GFA AD-617
(ISSUE 1)

GFA AIRWORTHINESS DIRECTIVE

TYPE AFFECTED: DUO DISCUS S/N: 1 up to & including 164.

SUBJECT: Possible faulty bonding of Upper spar cap to Spar web.

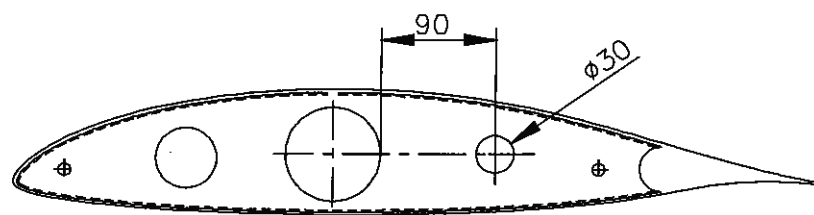
II. Deficiency in the bonding of more than 15 mm from the edge of the web or exceeding 40 mm in length or within the flange of the spar web

1. In the area of the deficiency sand the spar web away and scarf the edge of the web flange.
2. After roughening of the spar cap and the surrounding spar web apply the following layers 92125 under 45 degrees over the area to be repaired:

wing station	numbers of layers 92125 under 45 degrees
from root rib inboard until 1100 mm (43.3 in)	6 layers for each side
from 1100 mm (43 in) root rib inboard until 3000 mm (118 in)	4 layers for each side
from 3000 mm (118 in) root rib inboard until root rib outboard	3 layers for each side

Remark: The minimum scarf length for one layer 92125 is at least 10 mm.
